Peer Review of ALPHA Full Vehicle Simulation Model

Assessment and Standards Division
Office of Transportation and Air Quality
U.S. Environmental Protection Agency

Prepared for EPA by
ICF International
EPA Contract No. EP-C-12-011
Work Assignment No. 4-03

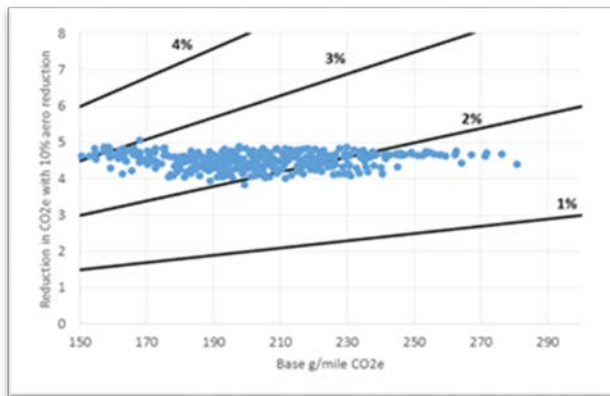
EPA Response: *The reviewer's conclusion and analysis shown in the chart above examines the effect of applying a constant vehicle road load reduction to three different powertrains. Our understanding of this comment is that the reviewer expected to find CO₂ g/mi reductions proportional (relatively equal to) to the base CO₂ g/mi, rather than near constant reductions in CO₂.*

Although in some circumstances the reviewer is correct that gCO₂/mi reduction is a function of the baseline fuel consumption, this general principle holds best for vehicles with a range of road loads but similar powertrain technology. On the other hand, the principle does not hold for vehicles with similar vehicle road loads but a range of different powertrain technology. The text box following this response contains a more technical discussion of the reasons behind this principle. The analysis in EPA's SAE paper³ compared vehicles with similar vehicle road loads, but different powertrain technology.

Runs similar to those referenced by the reviewer were also completed by Argonne National Laboratory using their Autonomie vehicle simulation tool.⁴ We used the Autonomie results to calculate the
